THIS DRAWING IS A CONTROLLED DOCUMENT.		DWN GOPALAKRISHNA HV		 TE Connectivity			
DIMENSIONS:		CHK RAGHAVENDRA					
		APVD RAGHAVENDRA		NAME END FEED HD-I APPLICATOR			
		PRODUCT SPEC					
		APPLICATION SPEC					
MATERIAL		WEIGHT		SIZE A3	CAGE CODE	DRAWING NO C- 1339706	RESTRICTED TO
FINISH		CUSTOMER DRAWING		SCALE		SHEET 1 OF 2	REV A1

PART NUMBER	REV	FIRST USED	TERMINATOR	FEED TYPE	DESCRIPTION
1339706-1	A		BENCH & LEADMAKER	MECH POST FEED	HD-I APPLICATOR
7-1339706-1	A		BENCH & LEADMAKER	MECH POST FEED	-1 AND SPARE PARTS
7-1339706-7	A		-	-	SPARE PARTS KIT

LAYOUT
L1339706

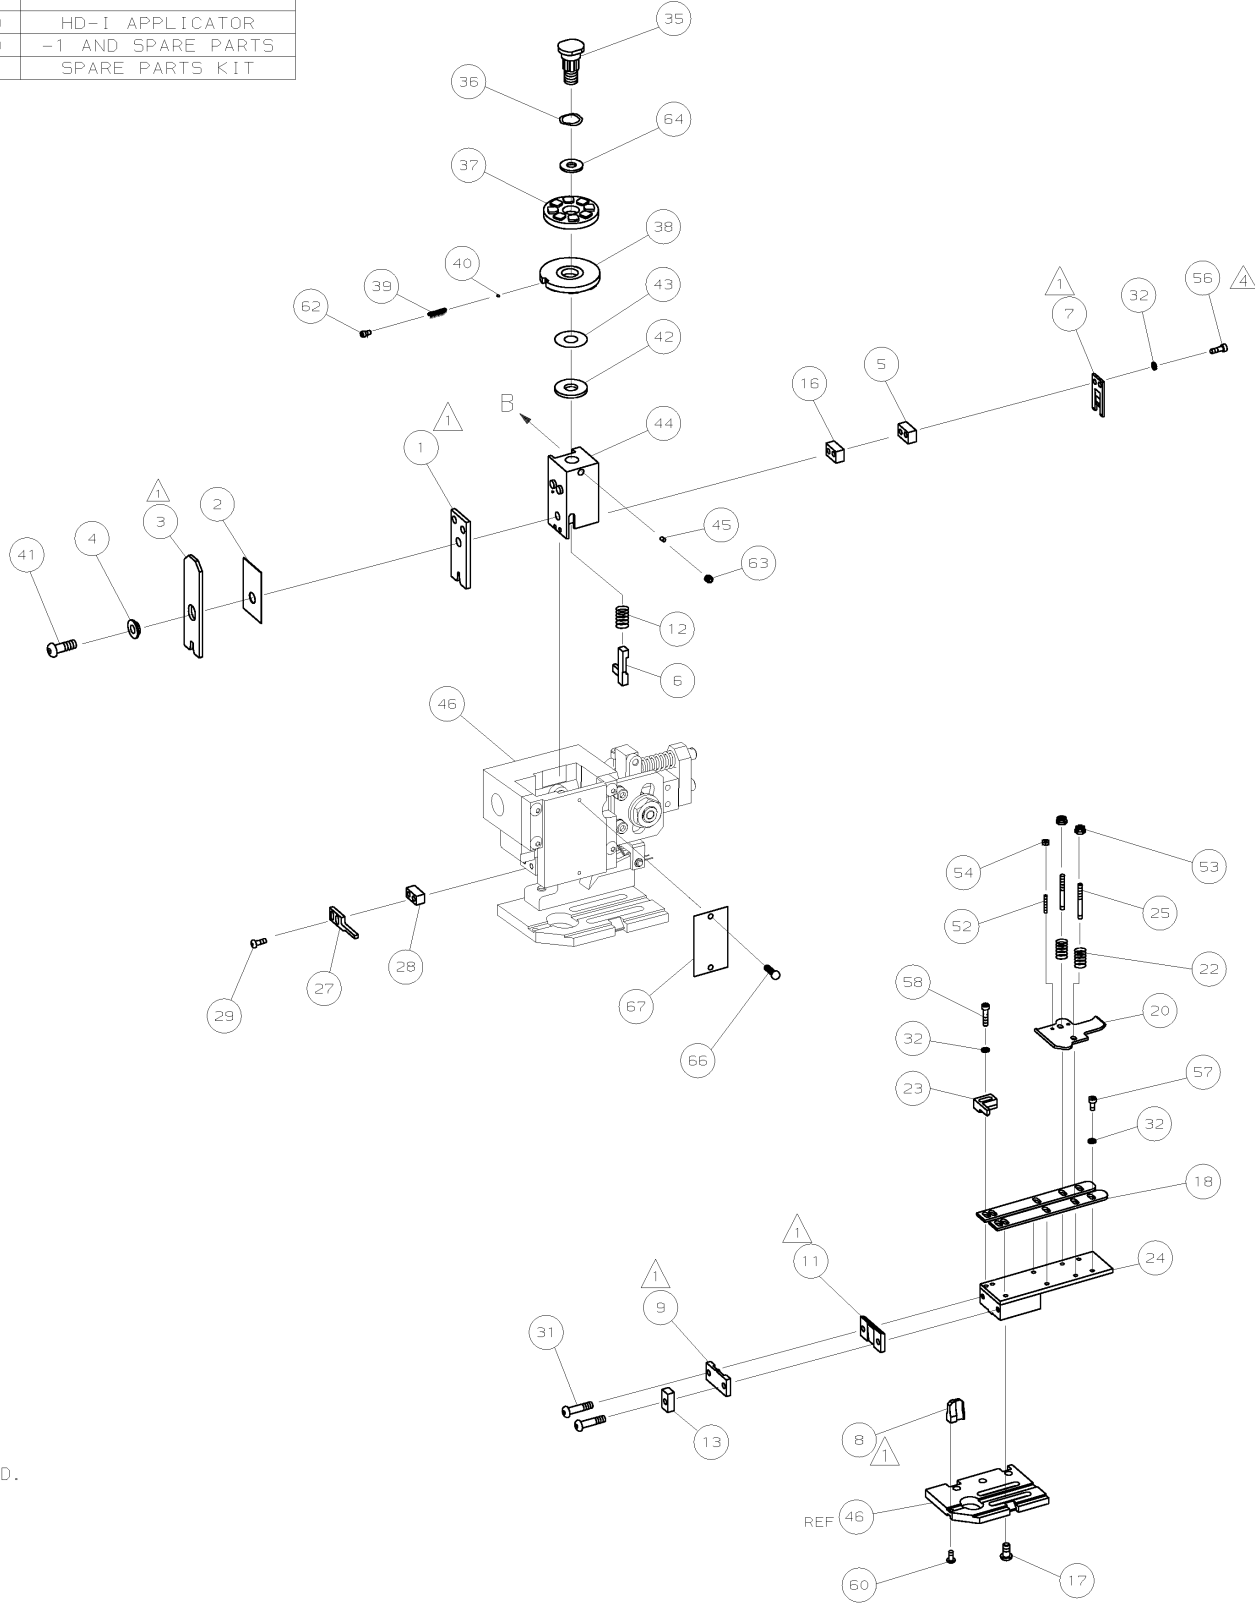
REPLACED BY OCEAN STYLE APPLICATOR PART
NUMBER 2150498-1

THE REPLACEMENT OCEAN STYLE APPLICATOR HAS THE
SAME TERMINATOR/PRESS INTERFACE AS APPLICATOR
1339706

FOR REPLACEMENT PARTS FOR APPLICATOR 1339706
REFER TO ADDITIONAL PAGE(S). SPARE PARTS KIT (IF LISTED)
WILL REMAIN AVAILABLE.
